UNITED STATES PATENT AND TRADEMARK OFFICE

APPLICATION NO.	FILING DATE	FIRST NAMED INVENTOR	ATTORNEY DOCKET NO.	CONFIRMATION NO.
10/724,171	12/01/2003	Richard Fouquer	031293	9397
23850	7590	09/09/2005		
ARMSTRONG, KRATZ, QUINTOS, HANSON & BROOKS, LLP 1725 K STREET, NW SUITE 1000 WASHINGTON, DC 20006			EXAMINER ADDISU, SARA	
			ART UNIT	PAPER NUMBER
			3722

Office Action Summary	Application No. 10/724,171	Applicant(s) FOUQUER, RICHARD	
	Examiner Sara Addisu	Art Unit 3722

DETAILED ACTION

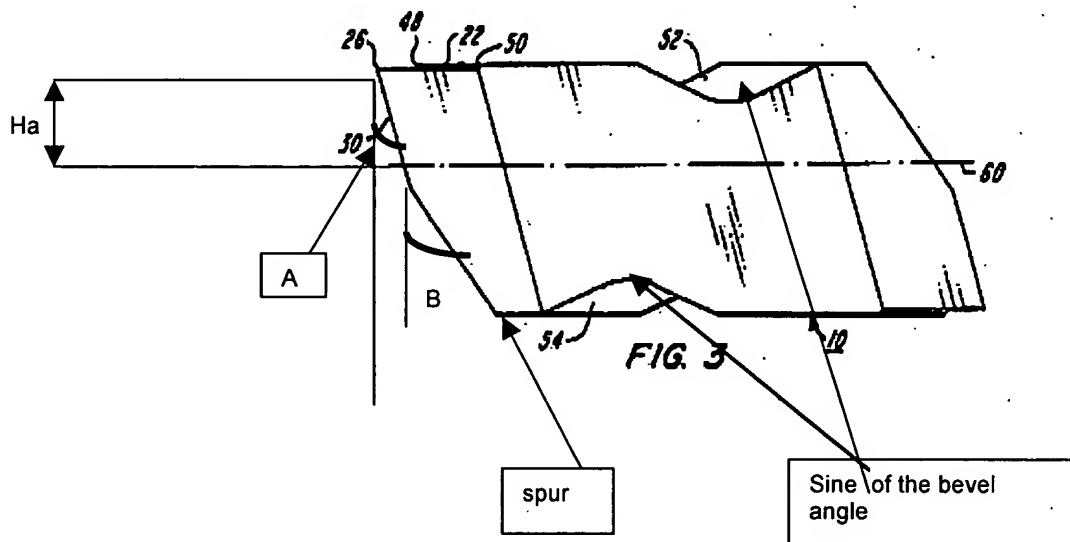
Niebauer teaches a cutting insert (10) with integral chip control feature and a laterally projecting tooth, used for threading applications (Col. 1, lines 5-7) bordered by a cutting edge (26) and a spur. Niebauer also teaches flank (14) supporting the cutting edge (26) with a profile having a thickness (Ha) and first relief angle (A), and flank (34) having a second relief angle (B) for bracing flank (14) ($B > A$) (See diagram below and Figures 1). Niebauer also teaches a two-sided insert with two projecting beveled profiles (30 with relief angle that is the equivalent of F1, see '893, figure 5 and having a predetermined widening starting at the tip edge and ending at the bracing part 34 with a variation in widening), therefore the insert has "different" surfaces extending from the flank such that the first relief angle (A) increases as the bevel angle increases (i.e. as a function of the bevel angle representing the sine of the bevel angle: see figure below). The bottom of sine curve represents the minimum threshold constant and the upward

slope representing the upper threshold with the height (position) of X between the upper and lower threshold.

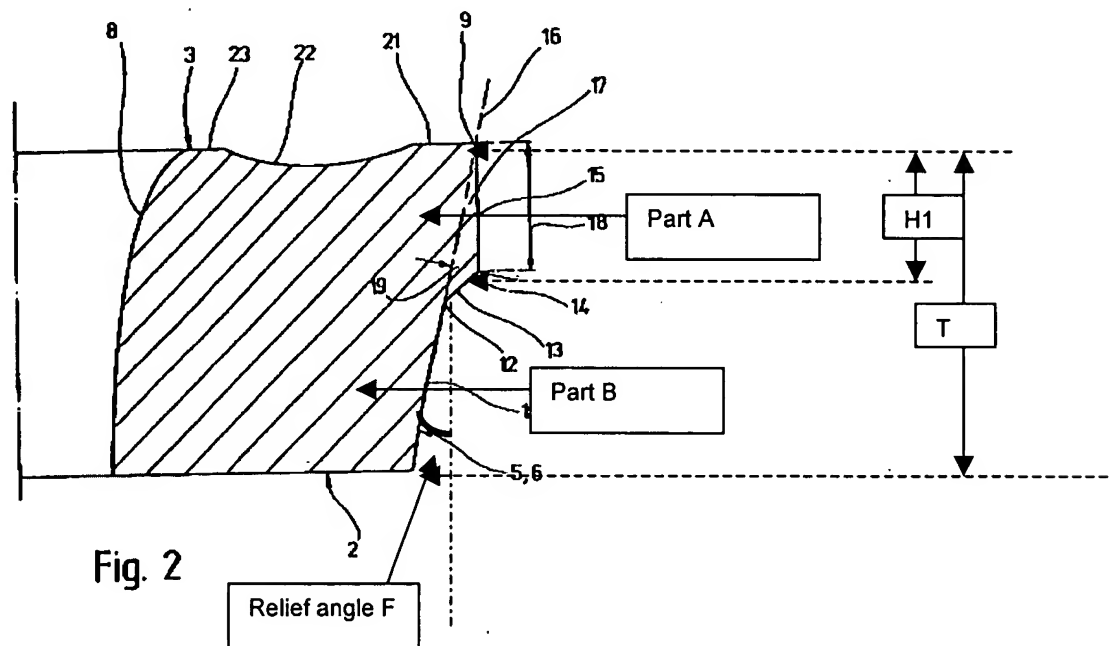
Vollmer et al. teaches a cutting insert having a laterally projecting tooth, bordered by a cutting edge (9), flank (15) supporting the cutting edge with a profile having a thickness (H1: which is between 10-50% of the thickness T) and first relief angle (zero degrees), a part (A) for bracing part (B) having a profile (11) where the rearward portion (11) has a second relief angle (F) and flank (34) having a second relief angle (B) for bracing flank (14) (the second relief angle F is greater than the first relief angle) (See

diagram below). Vollmer et al. also teaches transitional face (13) having a third relief angle. Furthermore, Vollmer et al. teaches a set back that is 1-50% of the lateral height of the tool (H1).

It would have also been obvious to one of ordinary skill in the art at the time of the invention was made to modify Niebauer's invention such that it has a setback, as taught by Vollmer et al. for the purpose of limiting the wear of the insert to the region between the cutting edge and the setback (S-shaped would be a matter of design choice). The feeding force, compared with a cutting insert lacking the setback, thus remains within certain maximum limits over substantially a longer wear distance

because the material of the strip defined by the setback is worn away first, and the material of the kind that is possible or present in the wear of a normal cutting insert lacking the set back is still then available ('536, Col. 2, lines 6-25).
